Ella Bay Integrated Resort Proposal

Supplementary Environmental Impact Statement

Submission Response:
1.8 DEWHA, EPA &
WTMA December
2007 (Addenda A)

1.8 DEWHA, EPA & WTMA December 2007 (Addenda A)

Figure 1.8.22: Aerial photograph with circulation paths and conservation covenant areas overlaid (Volume 3, Section 3.1)

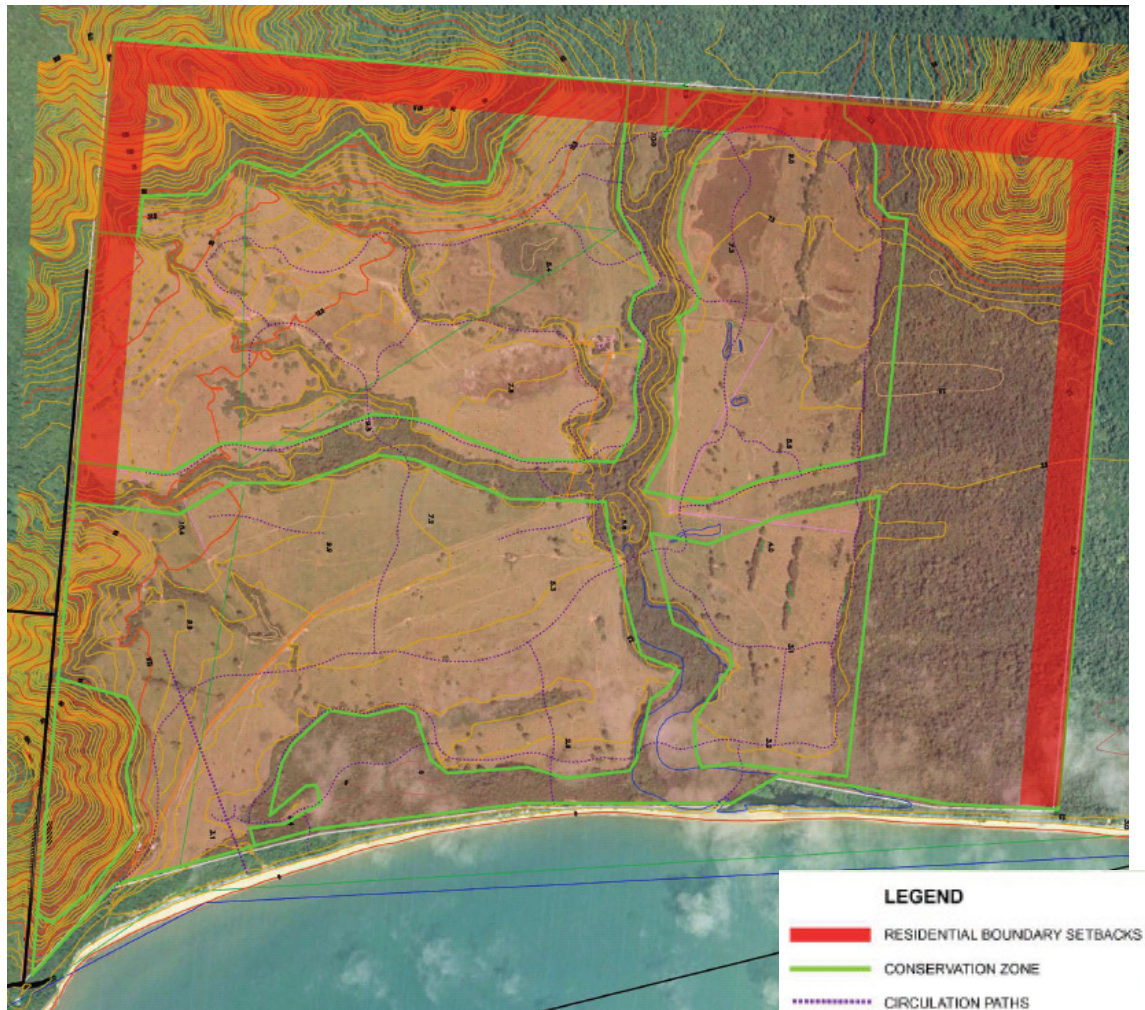
It is the Departments view that all infrastructure including cycle paths and pedestrian access roads, service infrastructure must be located outside all fauna corridors and set back areas.

Since the EIS and Draft SEIS, pathways have been modified where possible to be on the extremity of the fauna corridors and setback areas. Some of these pathways will also be required to enable practical functioning of the golf course. The final location and extent of these pathways will be determined to minimise impact and provide efficient connectivity at the detailed design phase. This could be conducted in consultation with EPA prior to Operational Works approval.

An indicative layout of the proposed pathways is shown in the following figure (Figure 1.8.22). The majority of pathways are in cleared areas or in vegetation that is non remnant. Boardwalks will be constructed over wet areas and paths will avoid or divert around significant trees or sensitive environmental areas (i.e. endangered and vulnerable plant species)

It should also be noted that underground service infrastructure will need to pass through areas under Conservation Covenant to link essential services throughout the development, however above ground physical infrastructure such as water tanks will be located outside of these covenanted areas.

Figure 1.8.23: South east corner of the development site (Volume 3, Section 3.1)

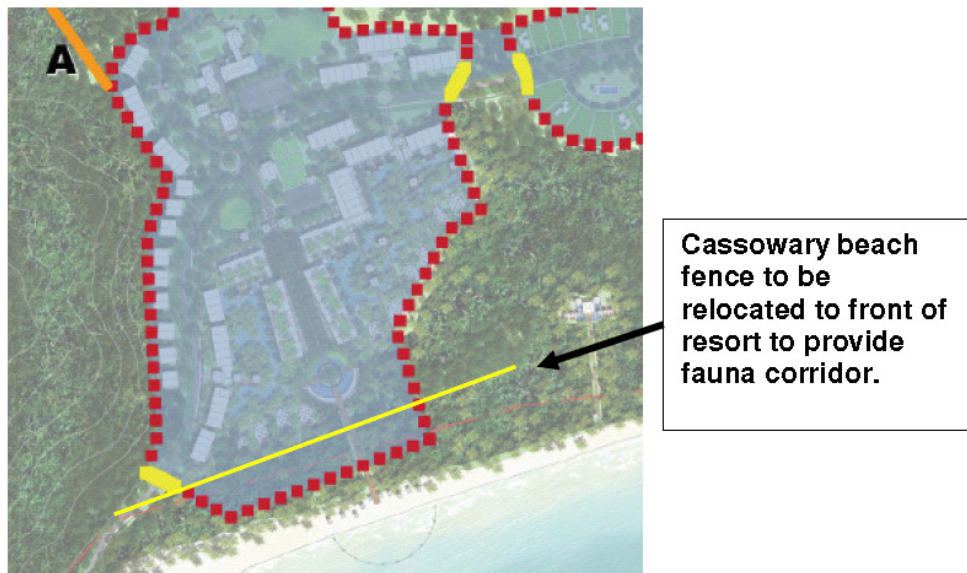
Options for a wildlife corridor in the south-eastern corner should be explored, to provide for wildlife movement to the coast there and along the entire frontage.

A wildlife corridor in the south-eastern corner will be provided. The fence in the Draft SEIS will be moved back from the beach in line with the more northerly fencing. The following figure indicates the proposed changes and has been incorporated into the revised master plan (see Volume 3, Section 3.1).

Figure 1.8.24: Flying Fish Point bypass to Ella Bay Road connection

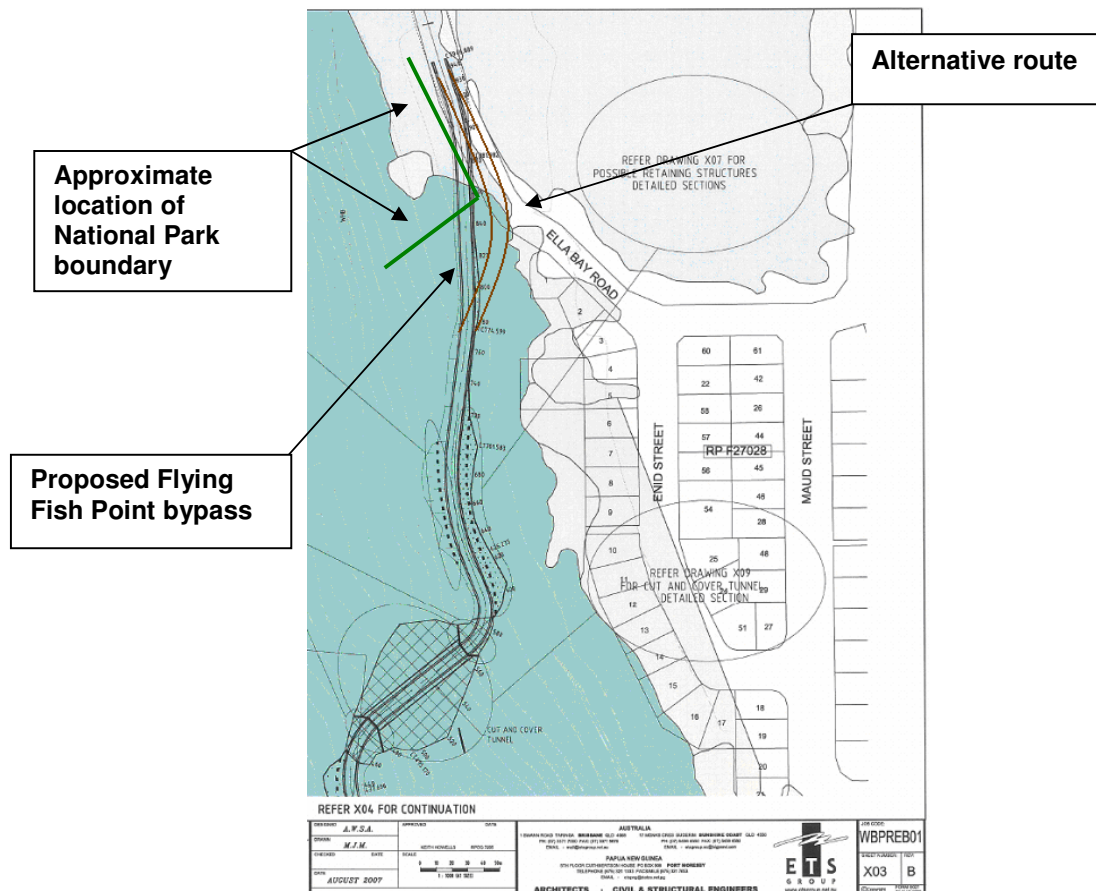
Does any section of the Ella Bay Road pass through National Park?

To the proponents knowledge none of the existing Ella Bay Road passes through National Park, as the road is contained within an infrastructure zone. Although a short section of the proposed Flying Fish Point bypass may encroach on a small portion of National Park (see Figure 1.8.24). The proponent has indicated an alternative route that can avoid the National Park, however this option involves passing closer to existing Flying Fish Point residences.

The area of road shown in Figure 1.8.24 that may be located within the National Park is approximately 0.09 hectares. The proponent intends to donate over 180 hectares to National Park and proposes a land swap with Queensland National Parks and Wildlife for this small section of road.
